Addendum No.1
to
CONSTRUCTION DOCUMENTS
for

May 21, 2025
2023159.00

NCISD New District Administration Building
21330 Valley Ranch Parkway
New Caney, TX. 77357
May 20, 2025

S201D1

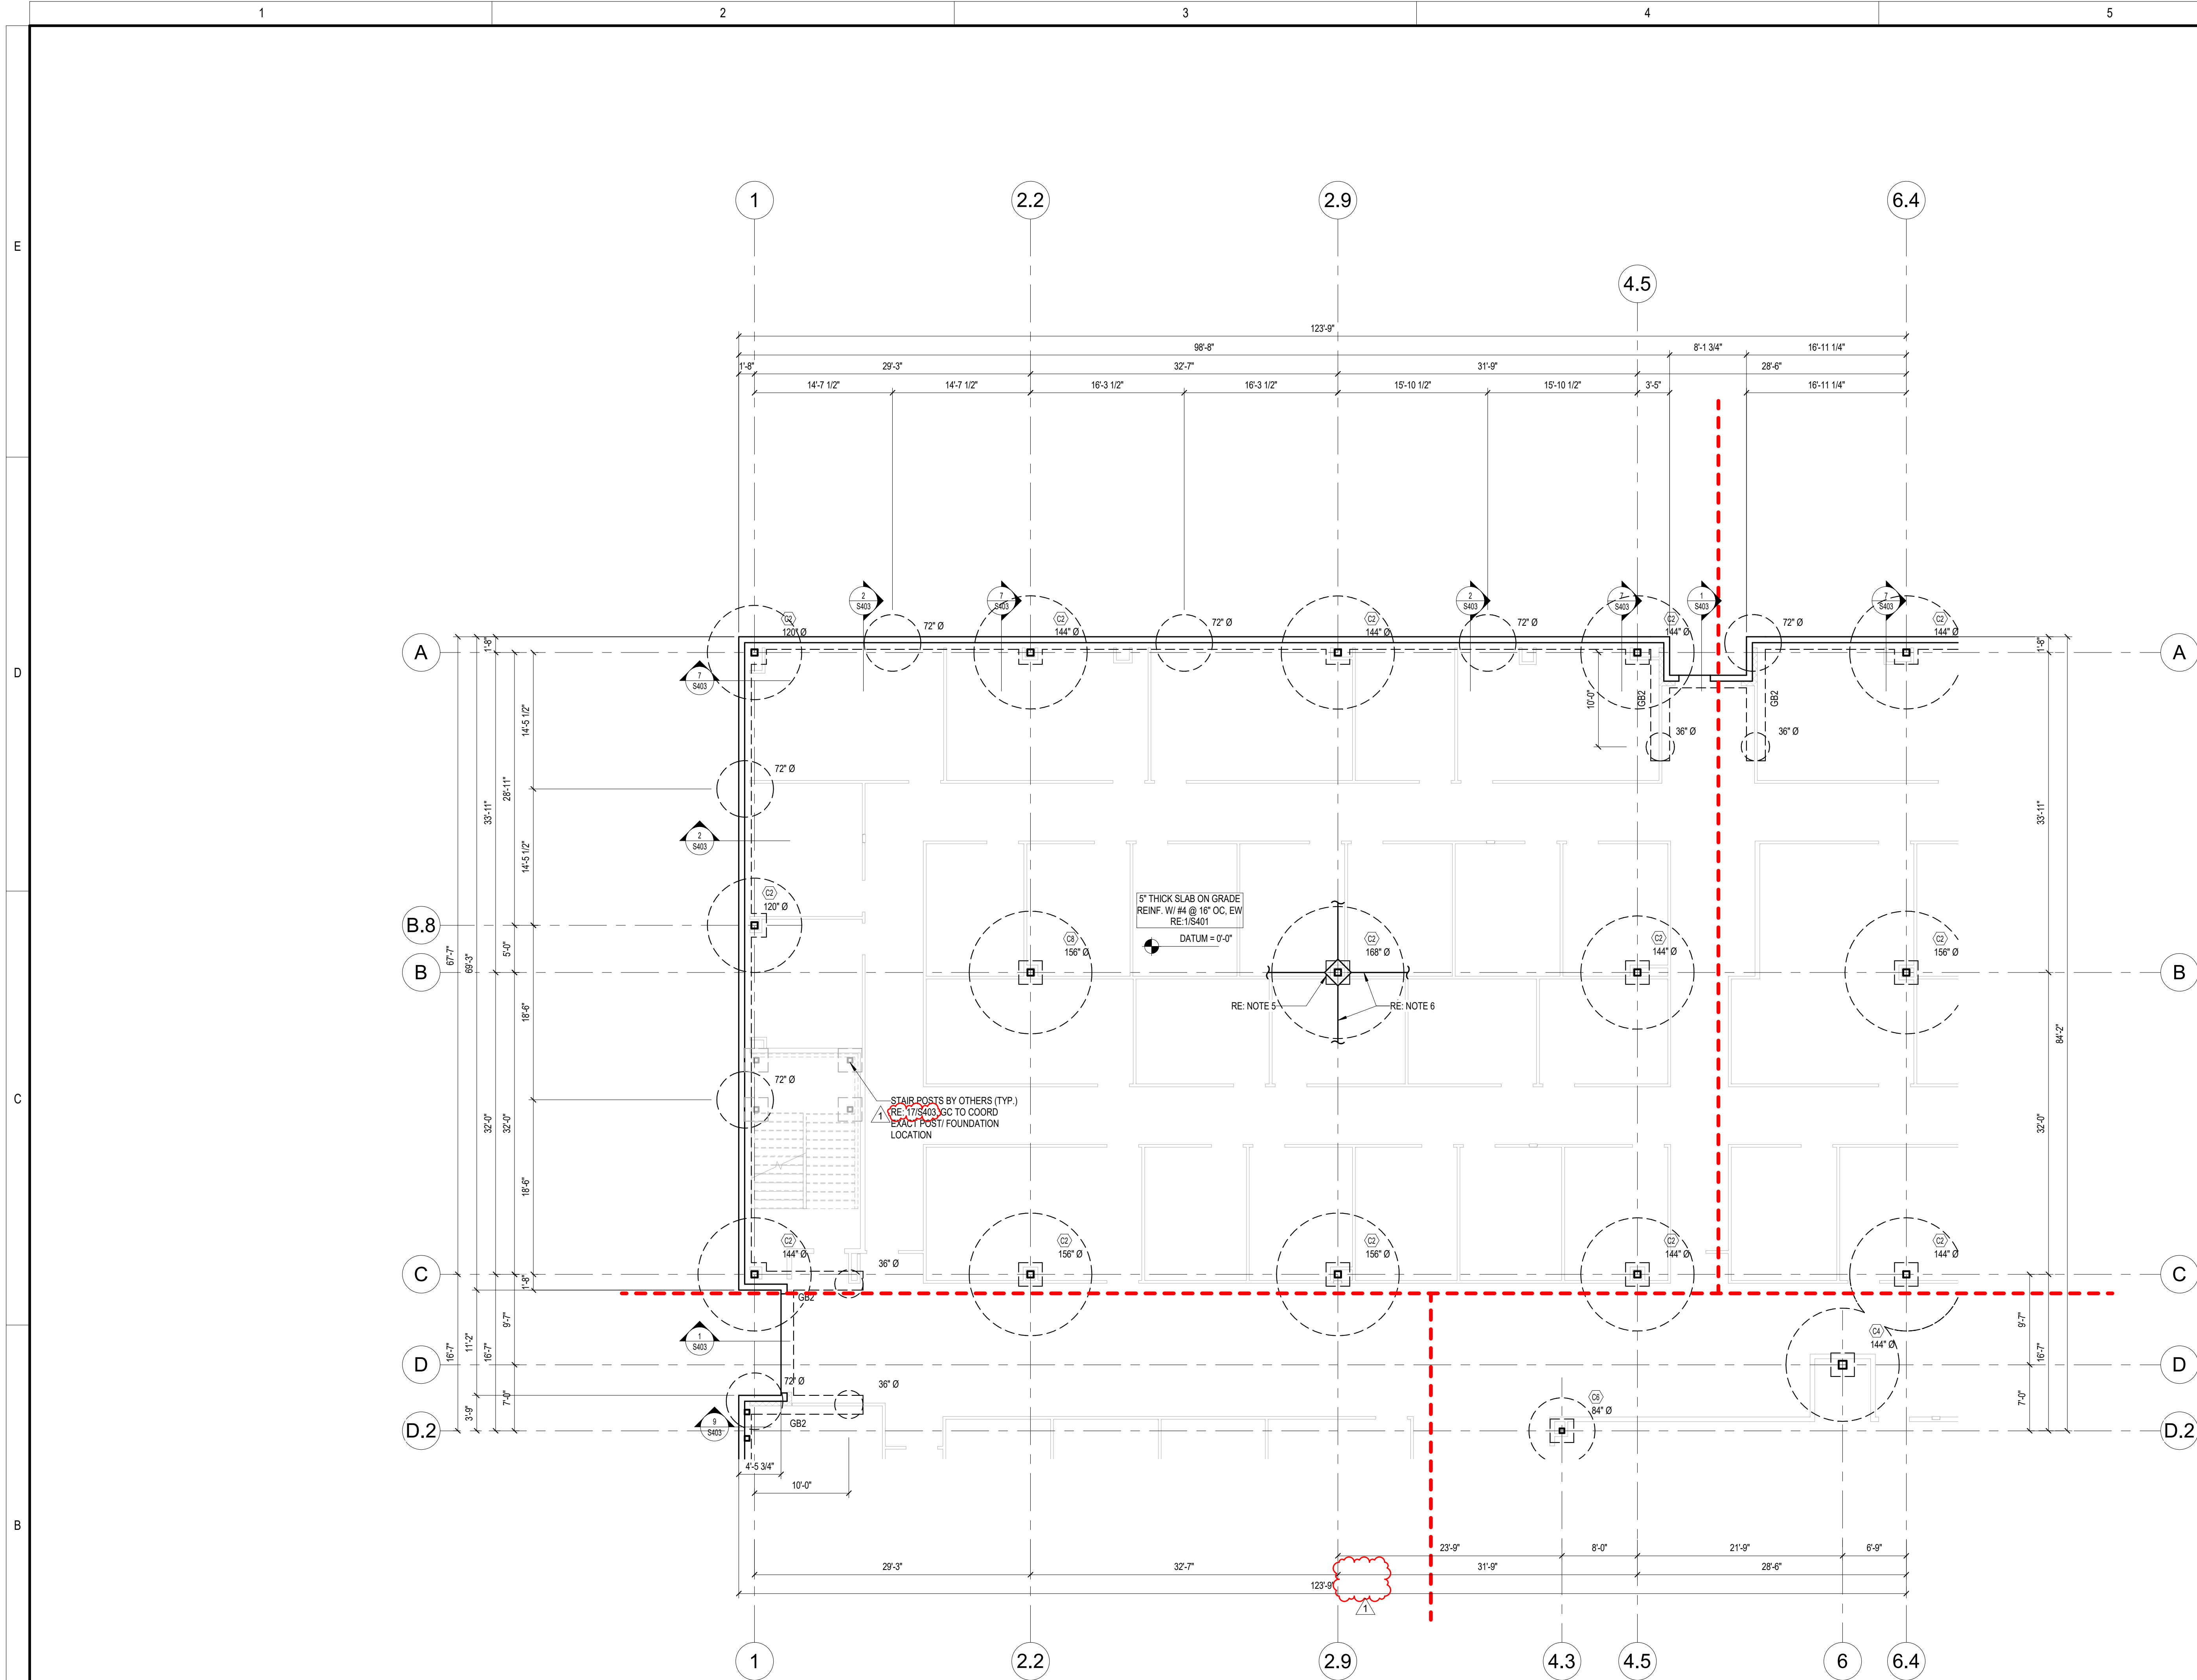
- o. "Sheet S201D1 & S201D1.2 reference foundation detail 19/S403, this detail is not included. Is this detail 17/S403."

Item No. 3 Sheet S201D1:

- a) Updated detail reference number

Answer: Yes, correction has been made to detail call out to reflect correct detail 17/S403.

S201D1.2

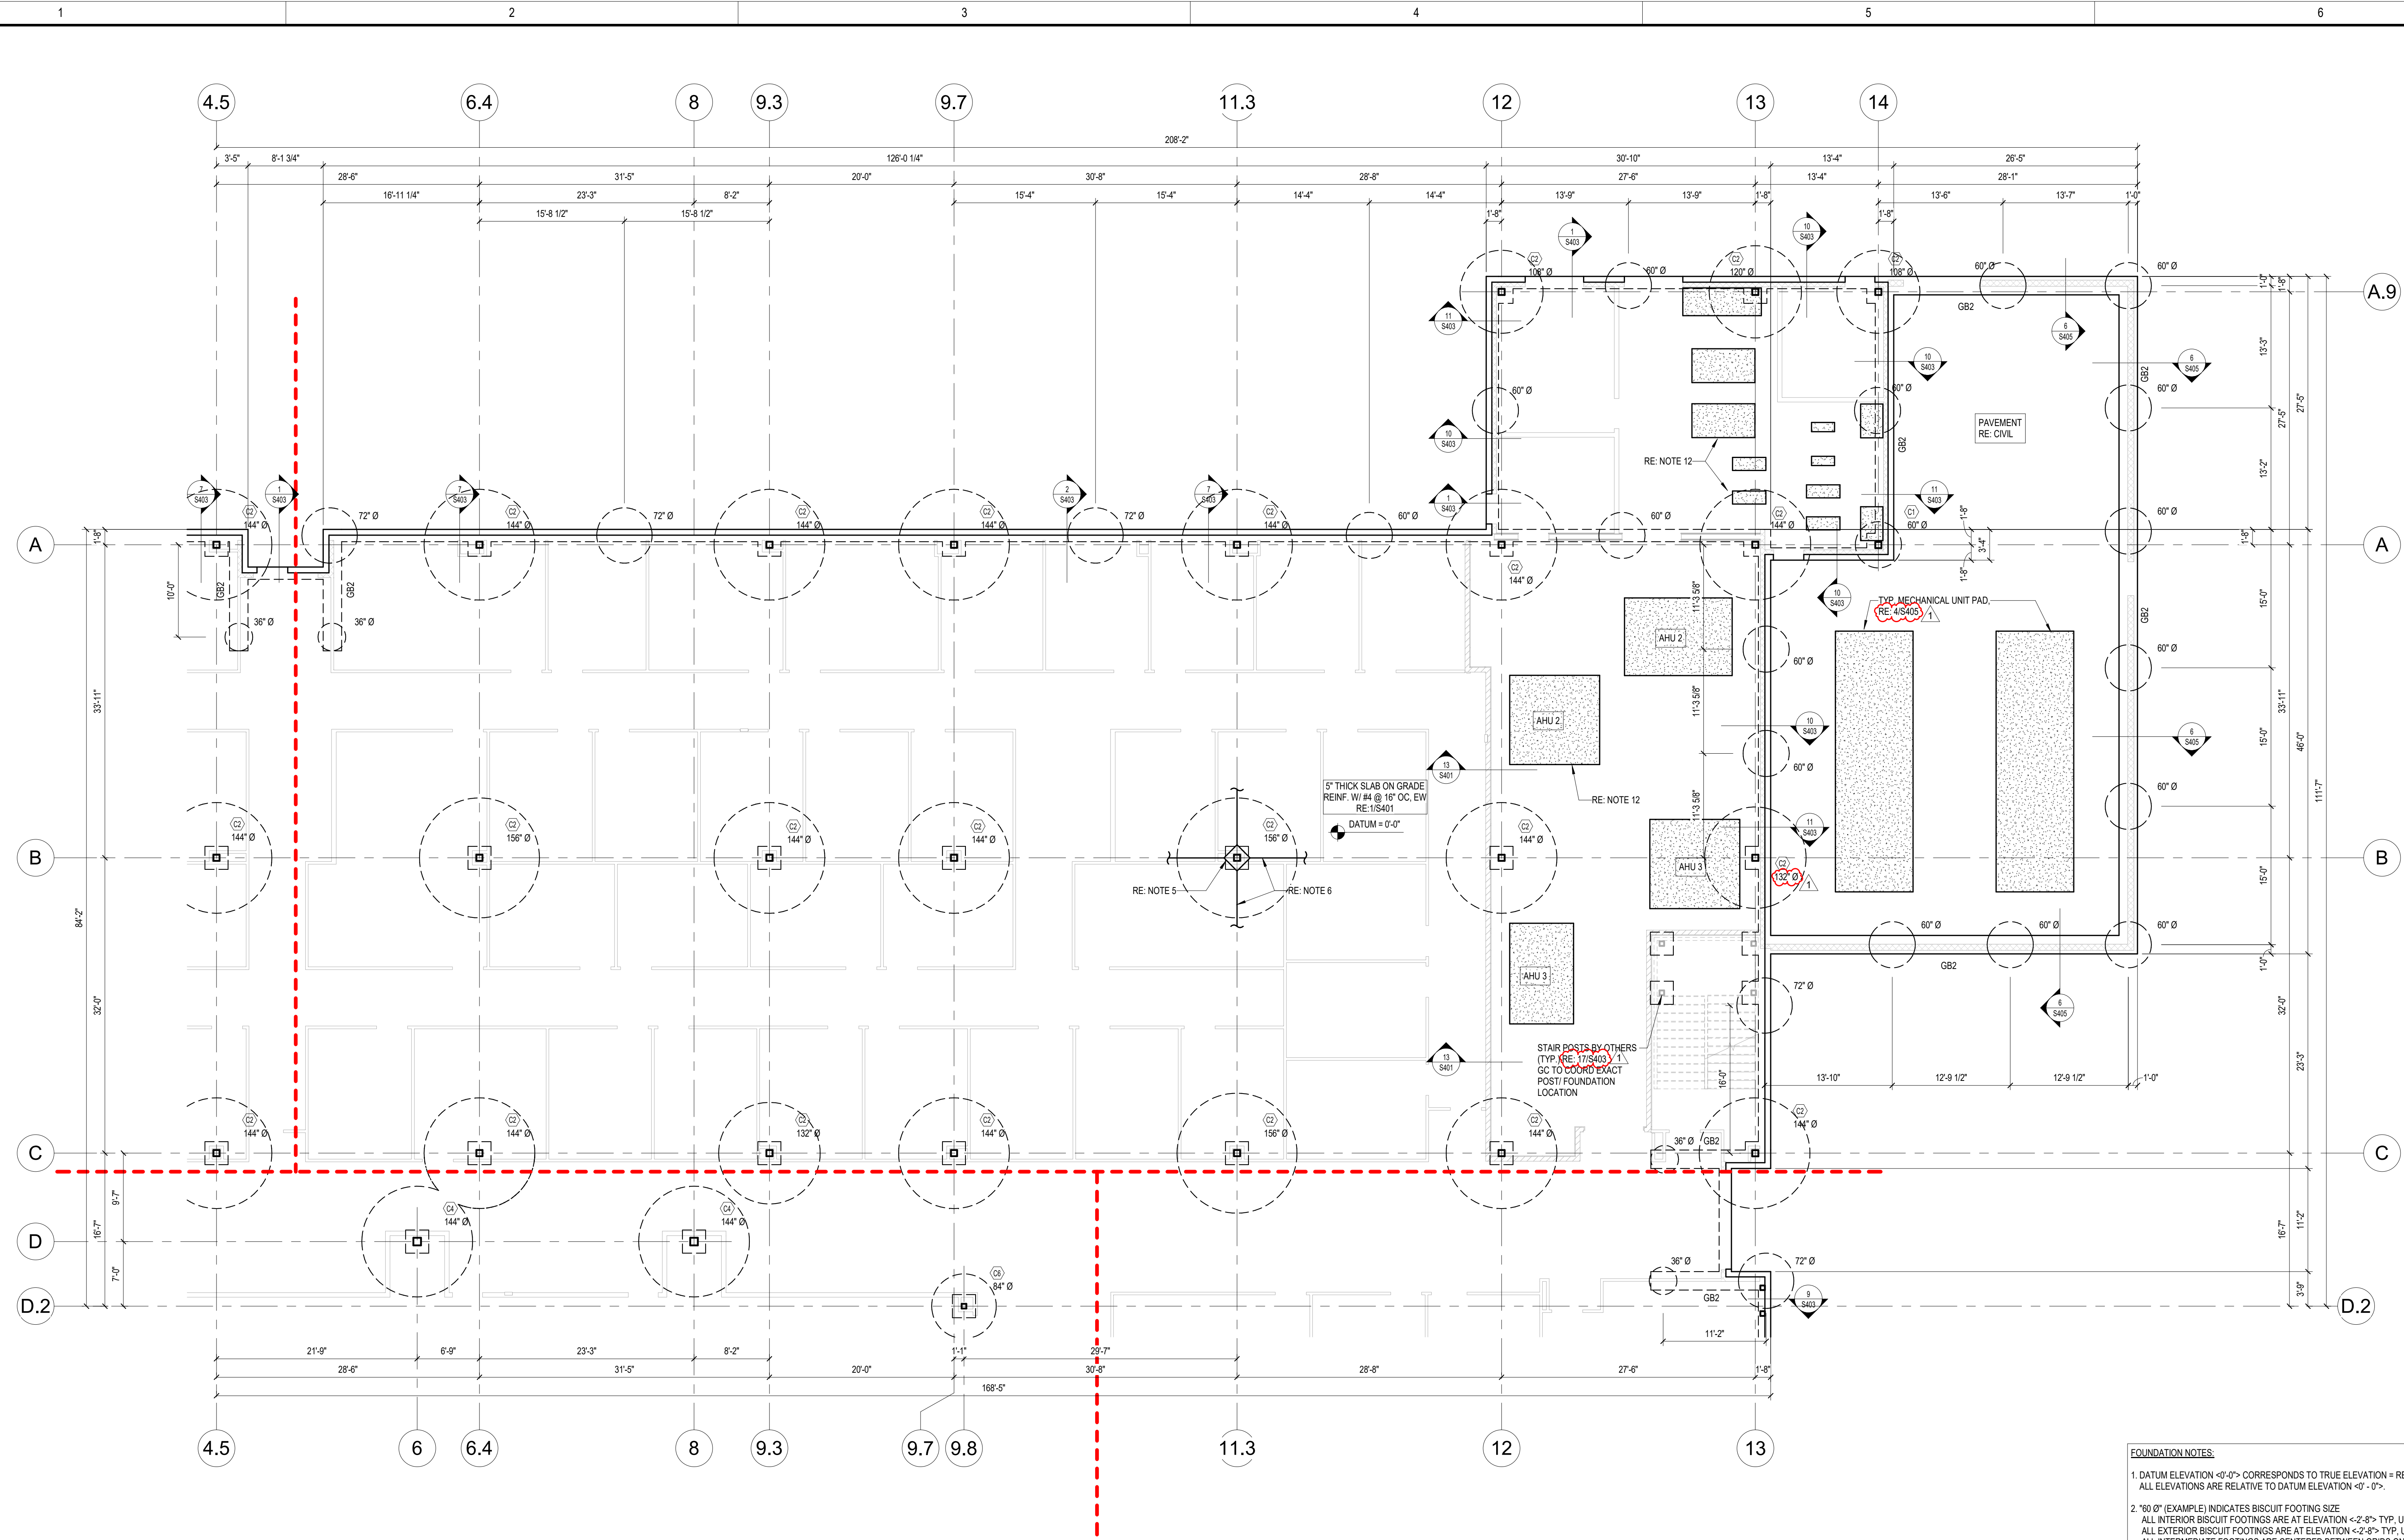
Item No. 4 Sheet S201D1.2:

- a) Updated detail reference number for stair post footing.
- b) Updated bisuit footing callout.
- c) Updated mechanical unit pad detail sheet reference.

S201E

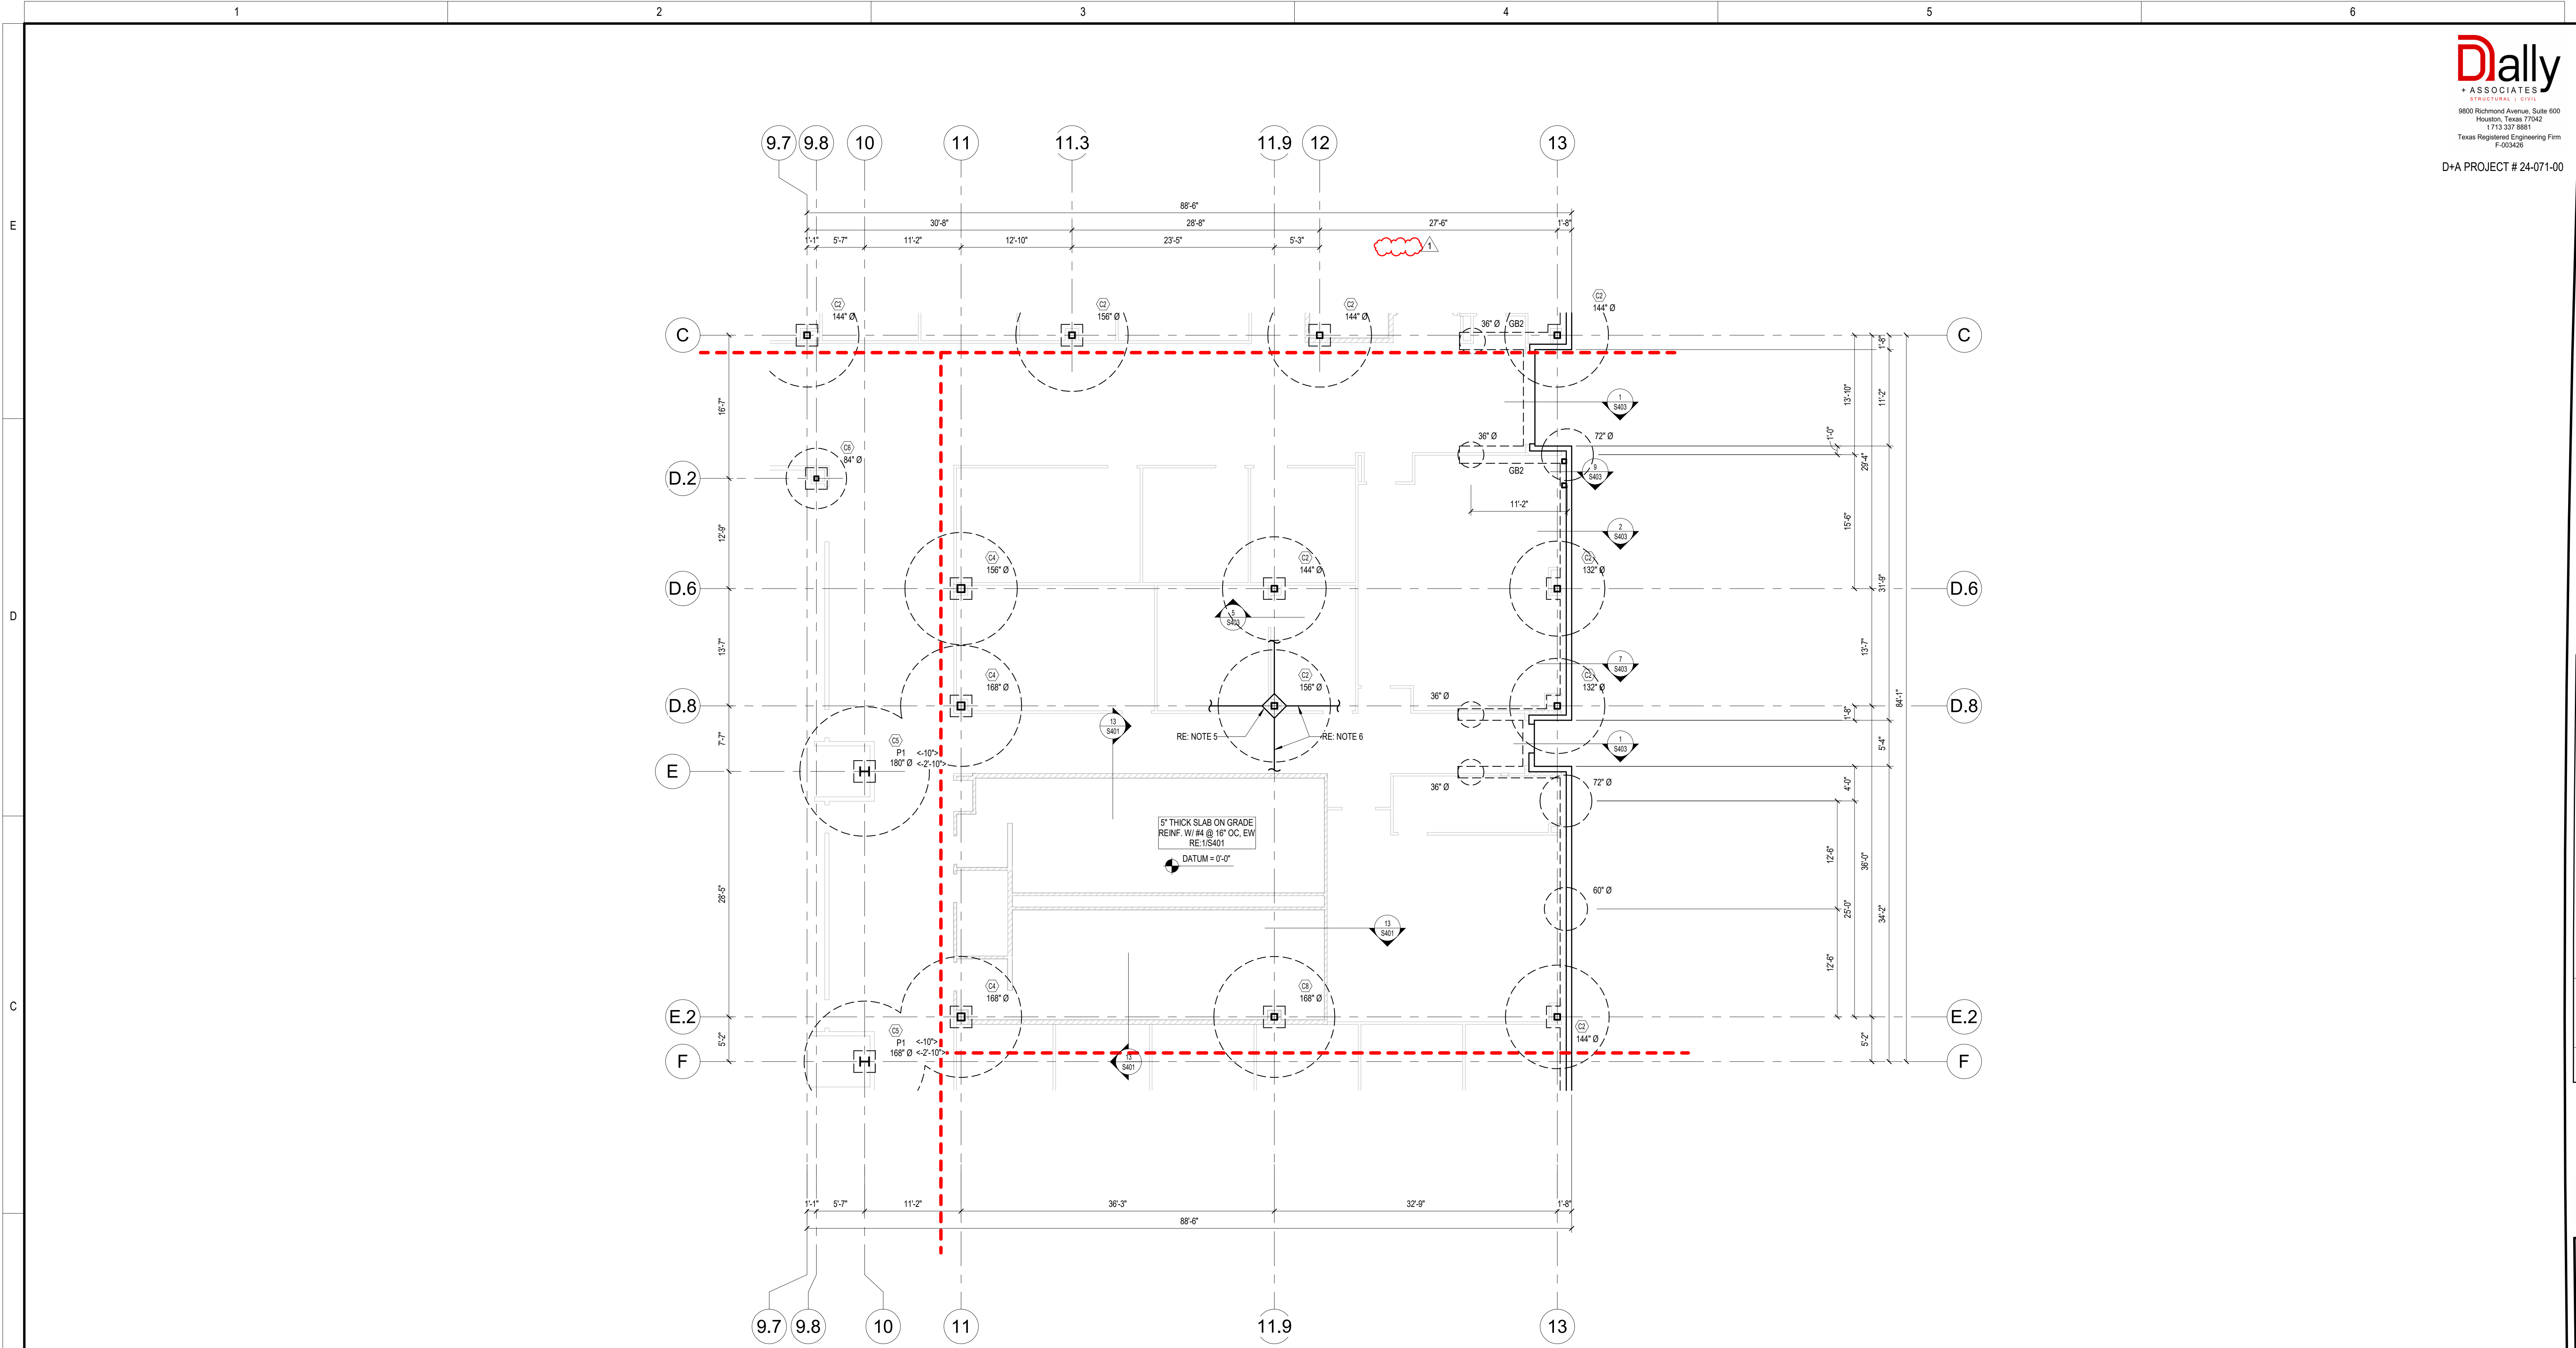
Item No. 5 Sheet S201E:

- a) Updated detail reference number for stair post footing.
